Report to Committee

To: Planning Committee
From: Jean Lamontagne
Director of Development
Date: April 19, 2007
File: RZ 06-355420
Re: **Application by Fairchild Developments Ltd. for Rezoning at 4000 No. 3 Road (formerly 4020, 4040 and 4060 No. 3 Road) from "Automobile-Oriented Commercial District (C6)" to "Comprehensive Development District (CD/183)"**

ABERDEEN STATION LANDS

TITLE: ABERDEEN STATION LANDS
 PROJECT NUMBER: A2.01
 SHEET NUMBER: A2.01

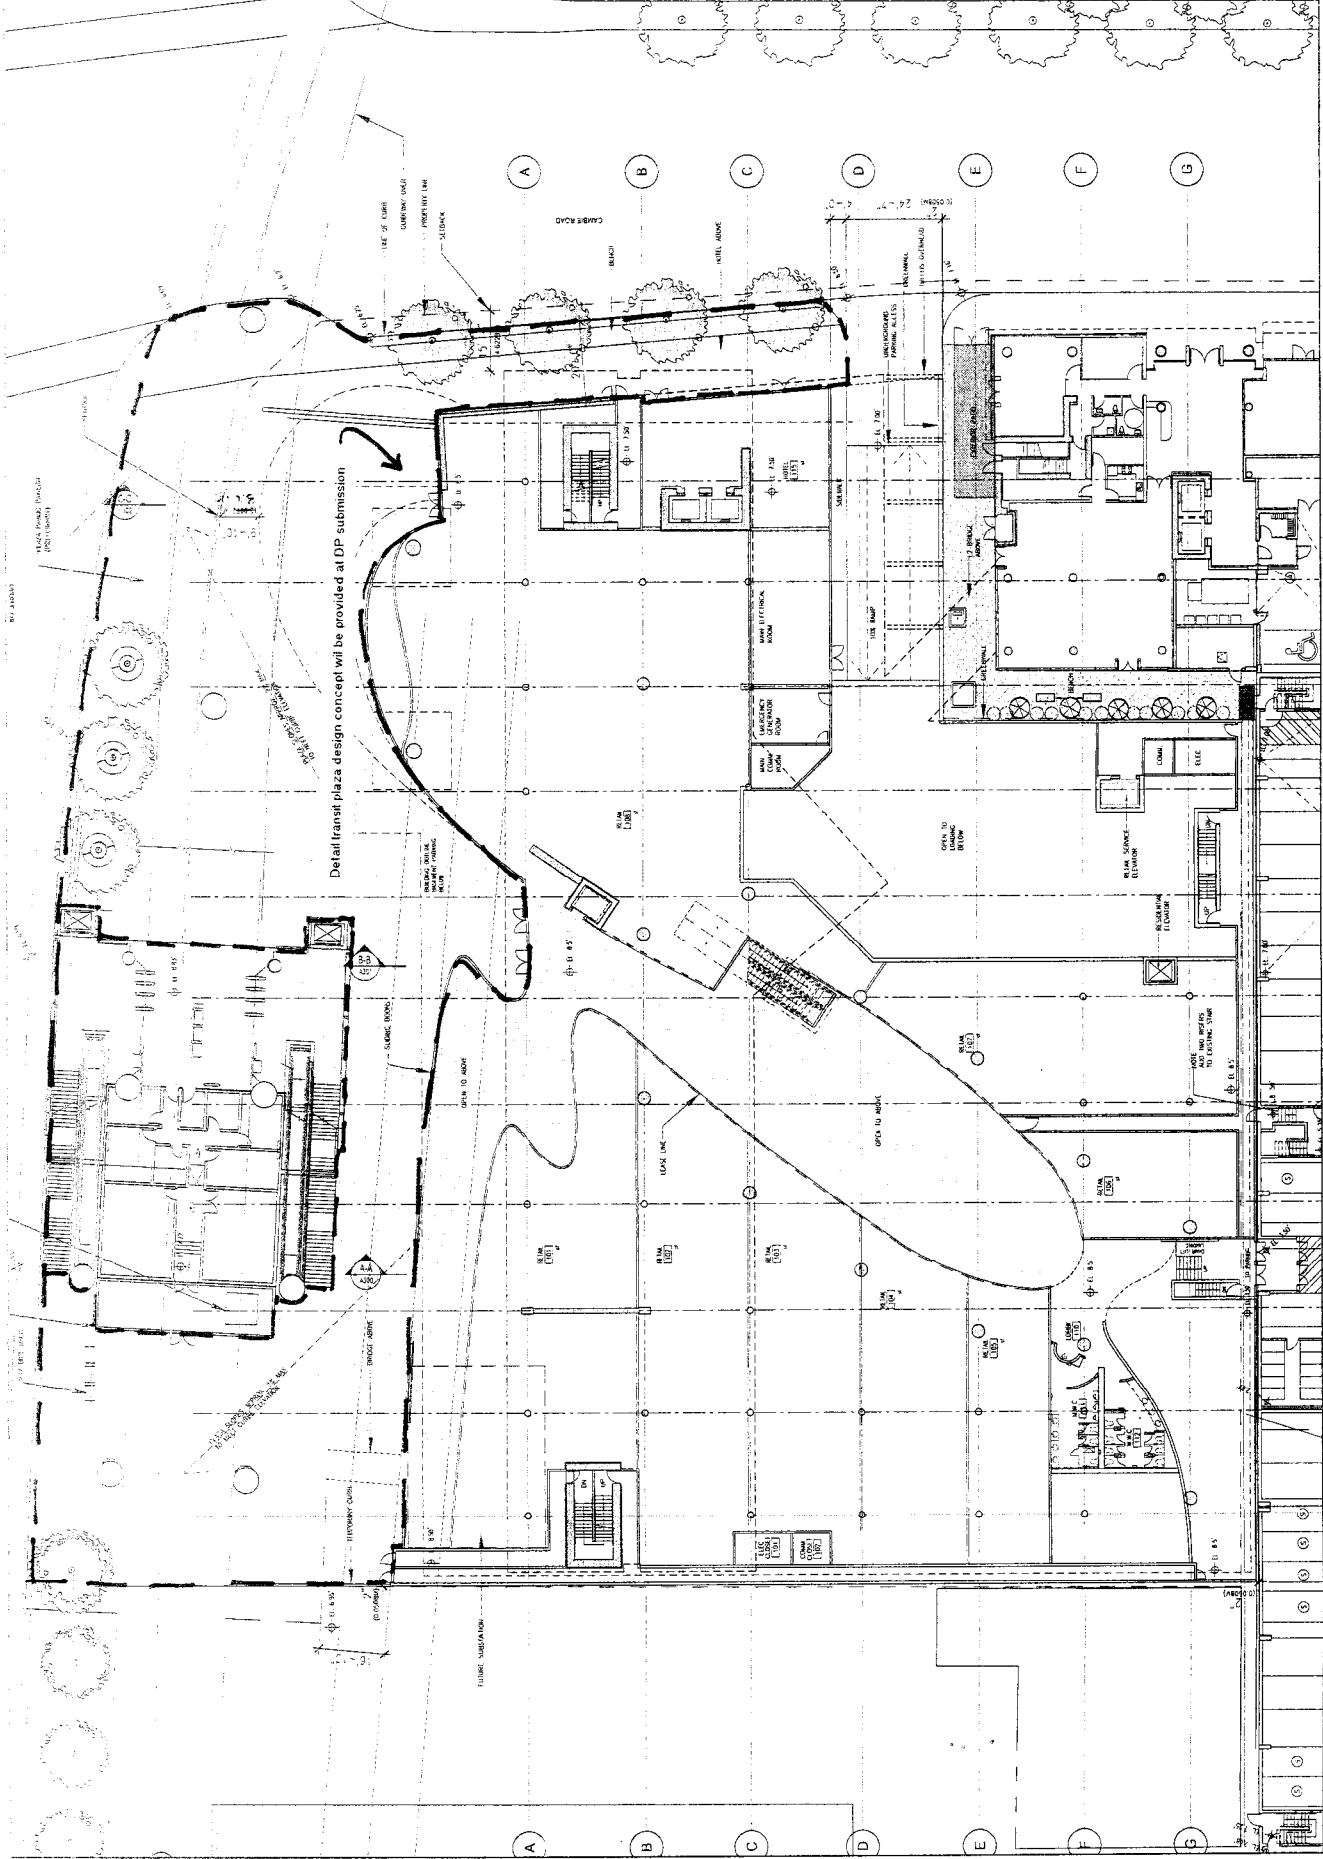
Detail transit plaza design concept will be provided at DP submission
